Subject: Grenfell Tower Grenfell Road London W11 1TQ

Thank you for asking me to visit the above premises yesterday, Thursday the 9th April 2015, to look at the **damaged boarding which covers in the electrical riser on each lift/flat lobby area, this damaged boarding is on the 2nd floor level opposite flat 23.** Any comments I may have, are numbered after each paragraph.

Sign on the staircase doors

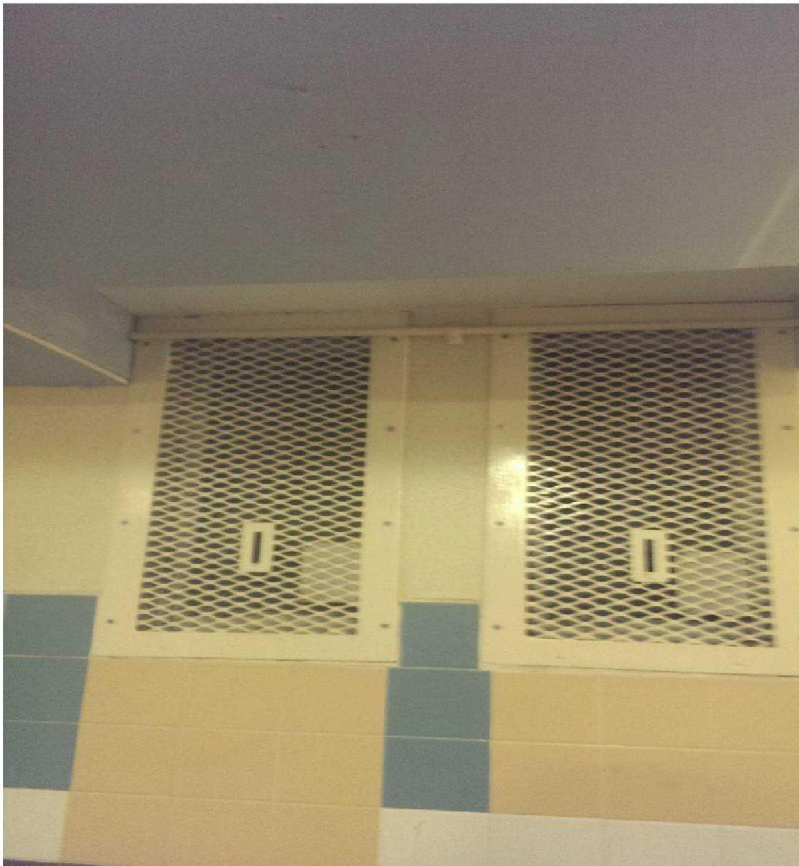
Signs have been placed on the staircase doors, stating that the "Staircase is for emergency use only". The staircase in this building is the normal route for the residents of this building as well as the means of escape route for the building's residents in an emergency situation. The staircase must be available to be used at all times and the residents must have the ability to leave the building at any time if there is a fire situation by a safe exit route. It is irrelevant that there is a "stay put" policy for the residents of this building if there is a fire in the building.

10. I would recommend that the signs should be removed from the staircase doors immediately, this is the buildings staircase and is not just an emergency route.

New ceiling around vents

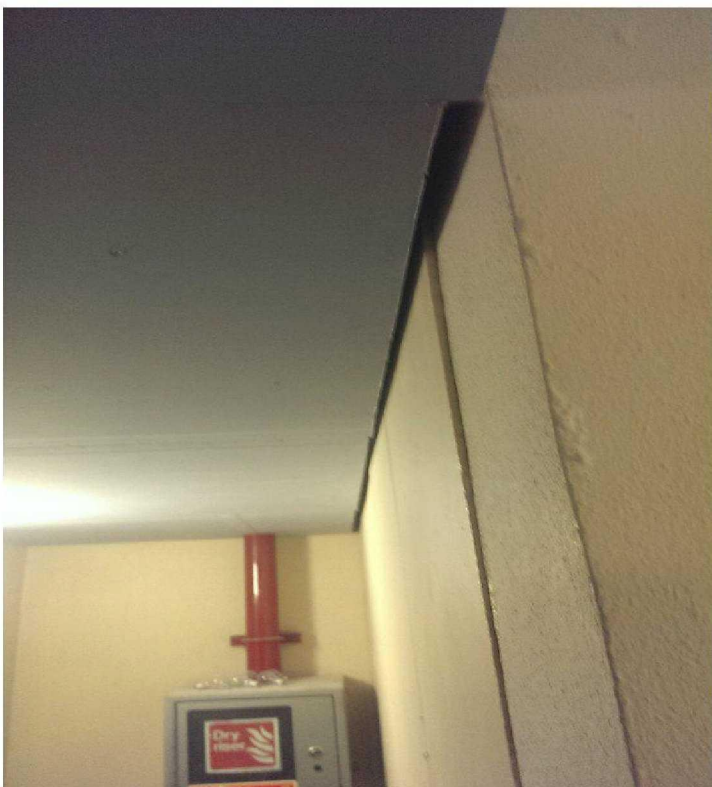
11. Can I ask what was in the TMOs specification about the fire rating of the ceilings and how they would abut the riser panels, as the contractor says that he is constructing the ceilings to the agreed specification.
12. The riser panels are not being replaced but there are being removed to be altered where the new ceiling joins up to them. I would commend that the contractor is asked just to check the fire stopping of each riser at the floor level when the panels are removed. If any fire stopping work is needed to the floors then I would recommend that this is undertaken at this time. This fire stopping should be of 1 hour fire rating.

Wall access panels to be cut at the new ceiling height so access to the electrical cable risers can be maintained

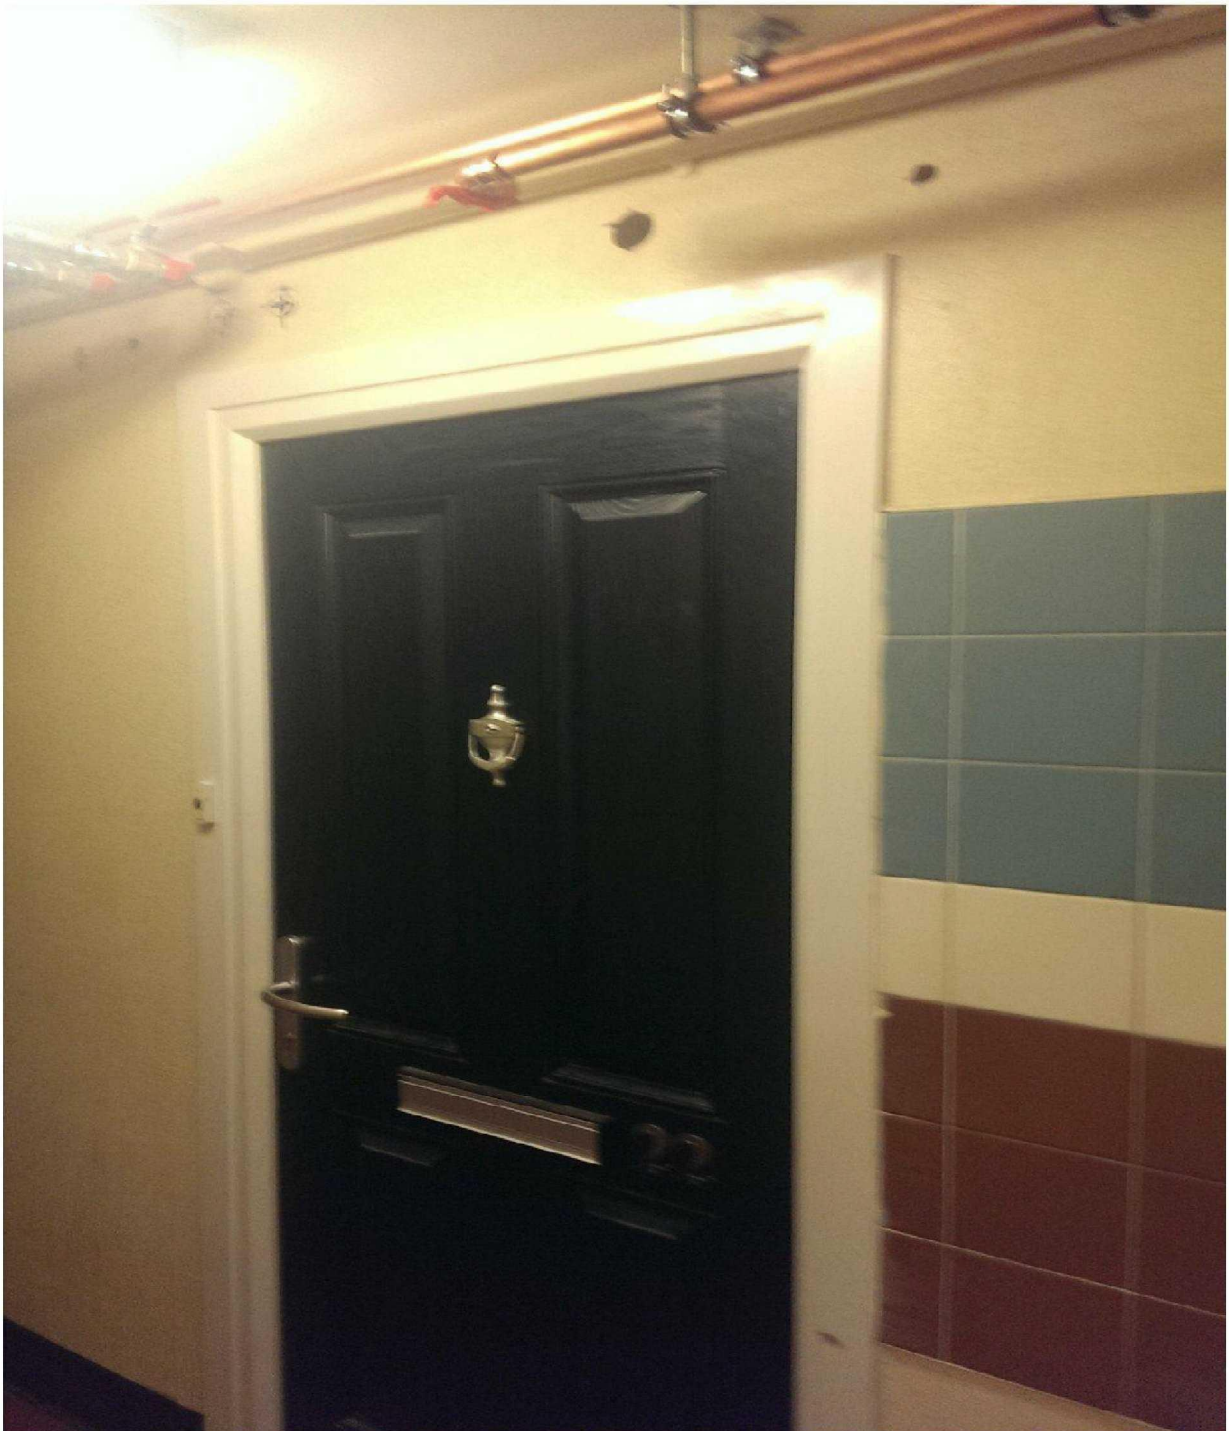
I was told that where the ceiling abut up to the walls the access panels of the risers are being cut at the new ceiling height so access to the electrical cable risers is maintained.
